Riley Purgatory Bluff Creek Watershed District Permit Application Review

Permit No: 2023-077

Project: Enclave at Manor Road Residential Development – The applicant proposes the demolition of an existing single-family home and the construction of a 17-lot single-family residential development.

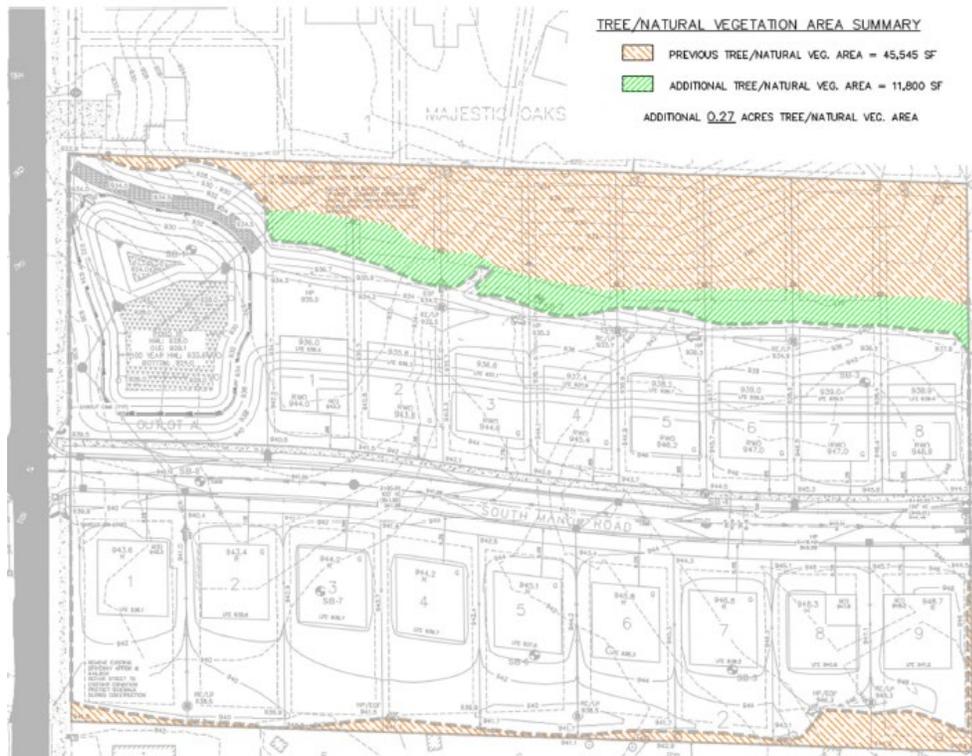
- Related to variance criterion 1 – As presented in the above rate control section, most of the runoff from the site discharges overland to the north to the neighboring properties, ultimately flowing into the storm sewer in North Maner Road under existing conditions. Rather than continuing to

discharge to the neighboring properties, the applicant is proposing to discharge treated site runoff to an existing storm sewer in the boulevard along 168th Avenue which conveys flows to the storm sewer in North Maner Road. The change in stormwater routing and the discharge location would result in between 0.9 cfs to 3.5 cfs of additional flow into the existing storm sewer. Because stormwater currently does not discharge to the NW, the deviations from RPBCWD standards are substantial.

Figure 1

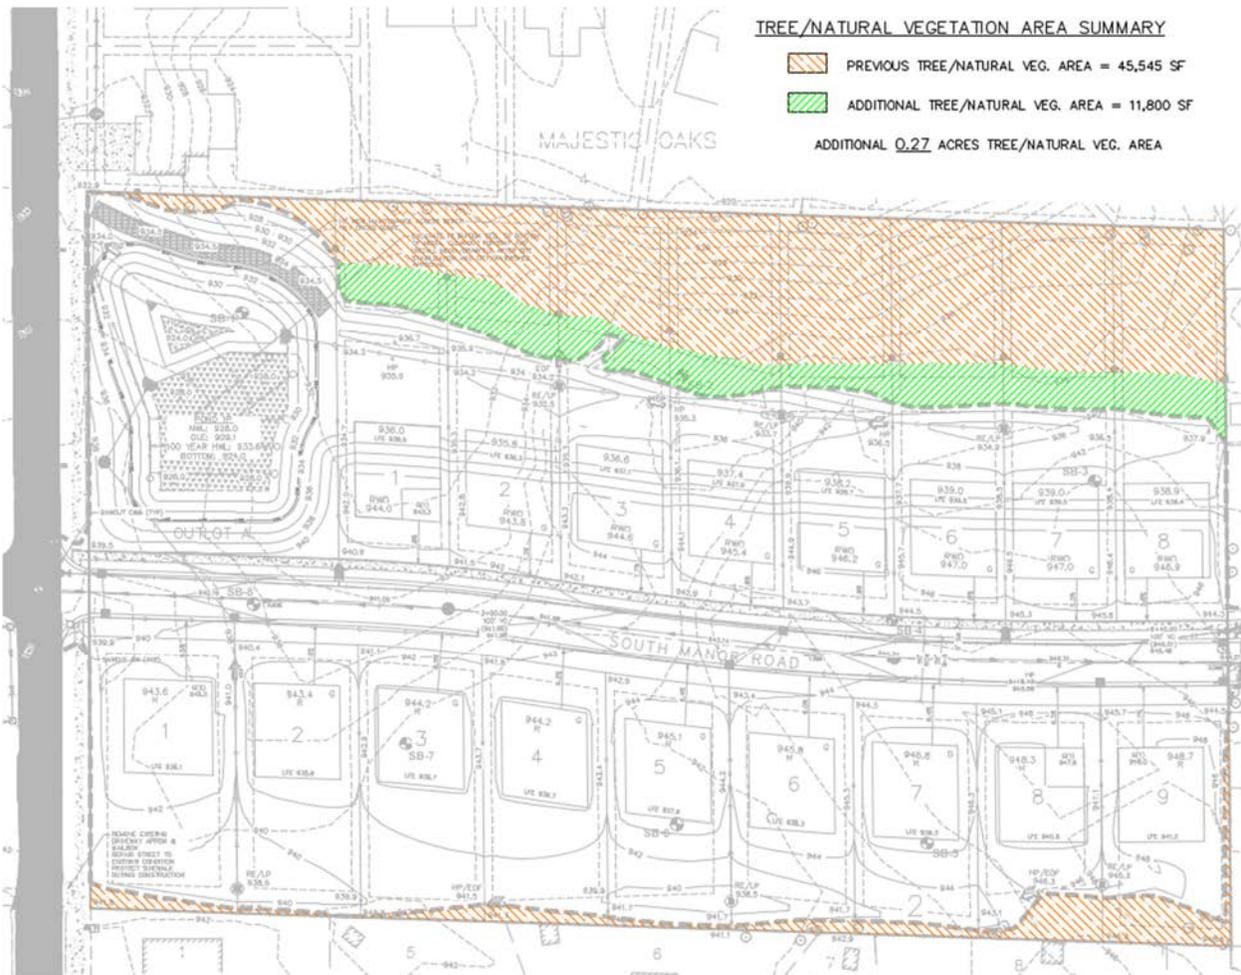
agrees with the Managers’ desire to preserve natural vegetation. Lot density reduction is not feasible due to Metropolitan Council density requirements for land development served by their sanitary sewer system. Therefore, modifications to the utility, grading and site design were made to reduce the cultivated lawn space and **save an additional 11,800 square feet of natural vegetation and trees**, bringing the total preserved space to over 1.3 acres as shown in the **Figure 1** below. This results in reduced rates of runoff to the 168th Ave. storm sewer compared to the previous design and significantly reduced runoff from the site as a whole compared to the existing condition, see **Tables 2 & 3**, respectively. Additionally, the water quality is improved as shown in **Table 4**.

Figure 2 – Source: RPBCWD

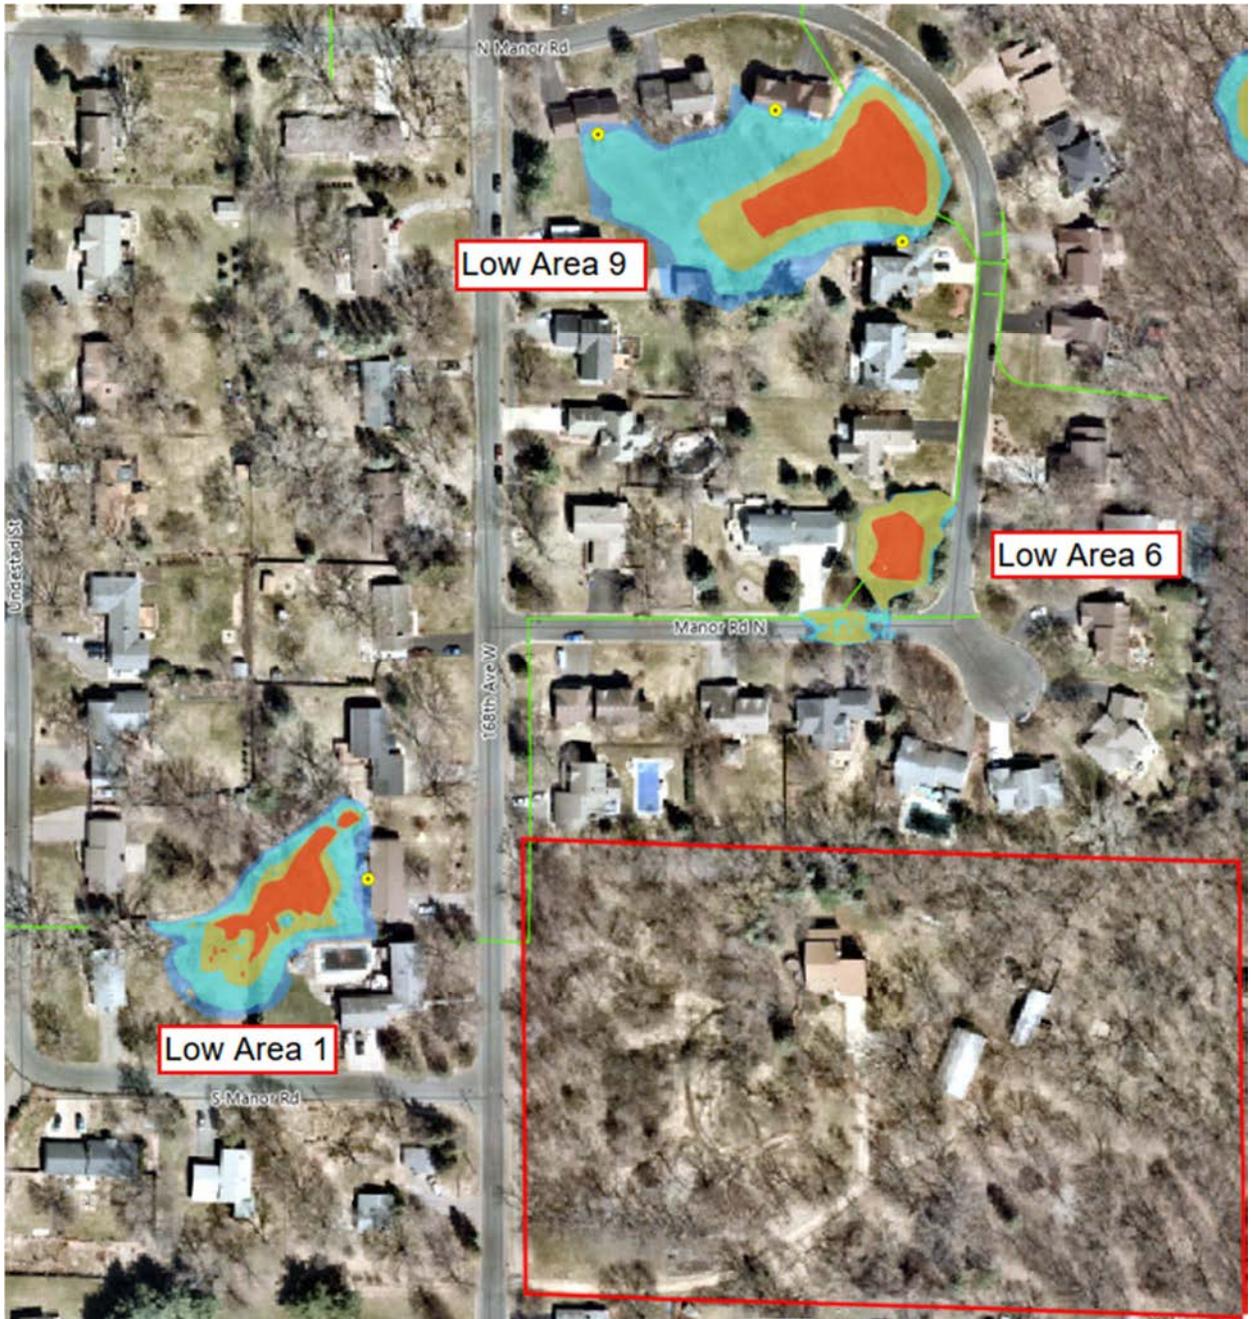
The site is restricted, meaning infiltration is not feasible. Rather, a biofiltration basin will provide water quality enhancements and minimal volume reduction via evapotranspiration. As a result, the high water levels (HWL) of offsite low areas will be affected by the proposed development. **Figure 2** shows the three regional low areas that are affected with the existing high water level inundation areas shown. All HWLs will remain the same or reduce for all critical events in the proposed condition with the exception of Low Area 6, which increases 0.1' during the 100-year event. This modified HWL will be contained within the existing public drainage and utility easement at Low Area 6. The existing and proposed HWLs are presented in **Table 5**.

LONG ROCK TRENCH OUTLET EXHIBIT

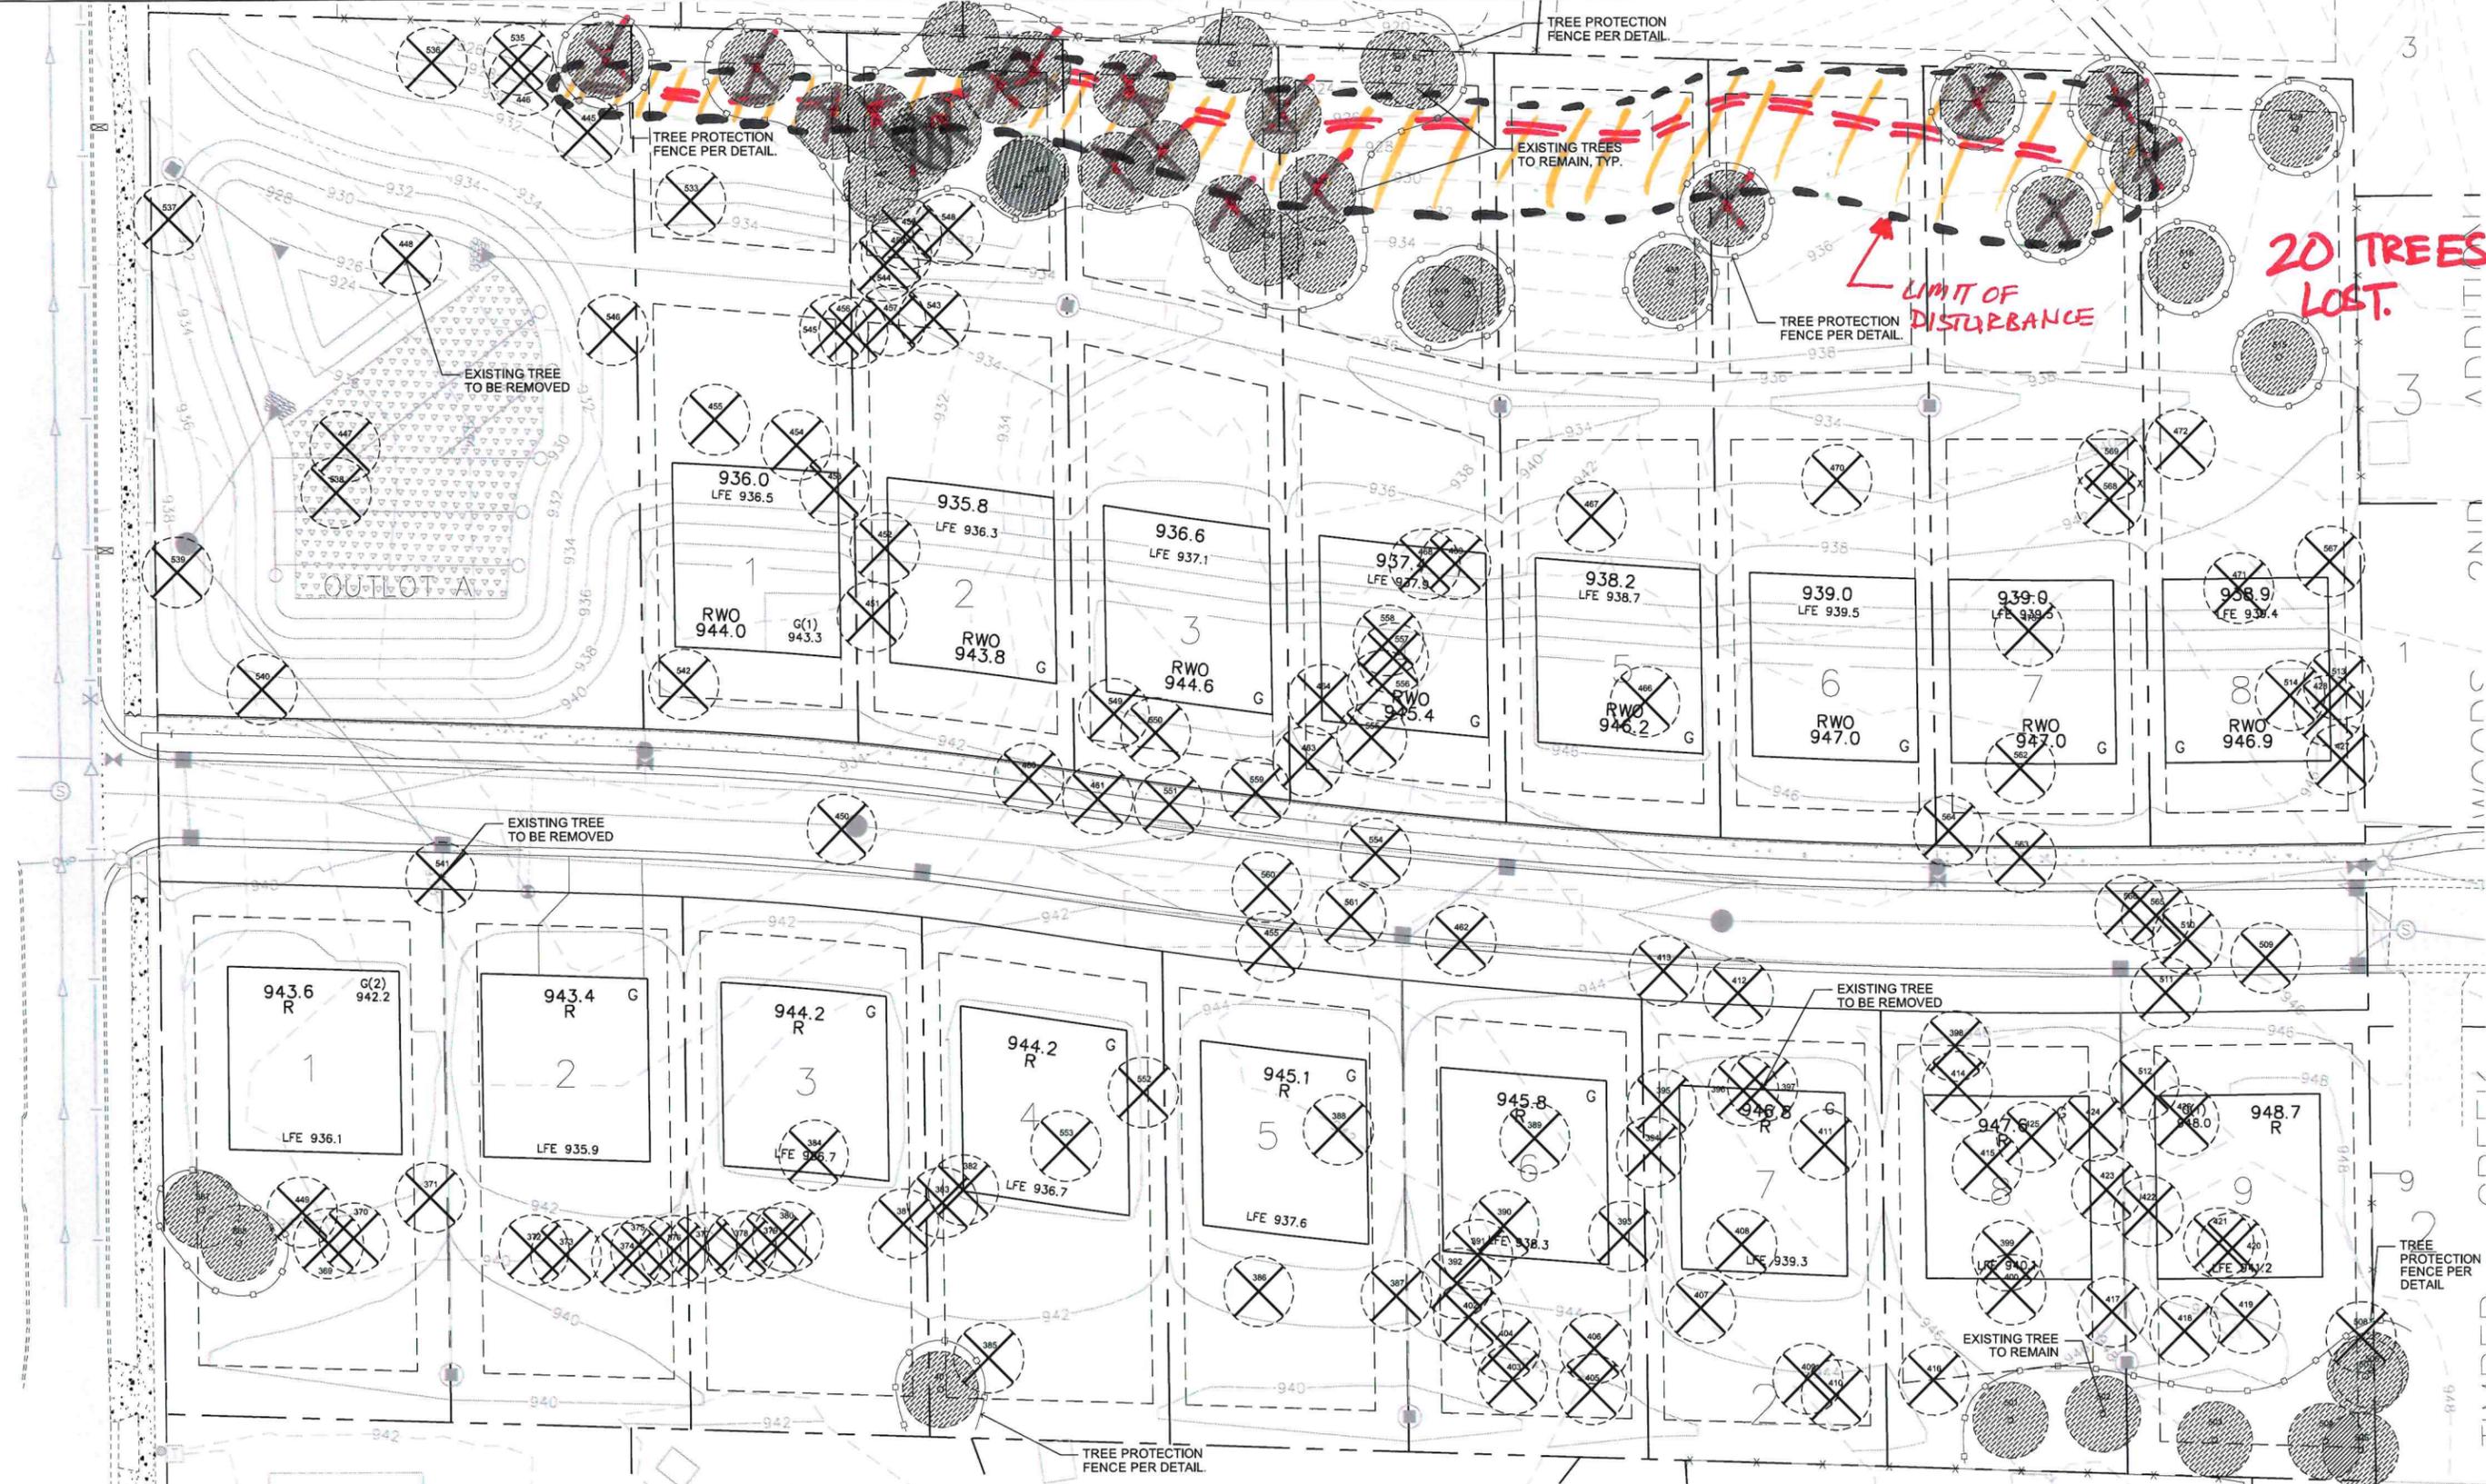
2) Long Rock Trench Outlet – This BMP would involve a long trench filled with riprap extending most of the east-west width of the site. Please refer to the exhibit in the appendix. The BMP would be downstream of a stormwater basin that would provide rate control, water treatment and volume abstraction. A perforated outlet pipe from the stormwater basin would run down the bottom of the rock trench. Water would distribute throughout the rock trench, filling it and overflowing to the north. The discharge from this BMP would be sheet flow, mimicking the existing flow to the properties to the north. As with the long weir wall, concentrated flow and erosion is a concern. Settling of the soil is inevitable, which could result in unequitable flow to an individual property to the north, creating erosion and safety issues. The City has several concerns with this BMP:

- *The rock trench would be extremely difficult if not impossible to maintain. It would have to be kept free of weeds and vegetation, requiring extensive maintenance and use of herbicides. Any sedimentation within the trench would be nearly impossible to remove without full removal and replacement of the perforated pipe and rock.*
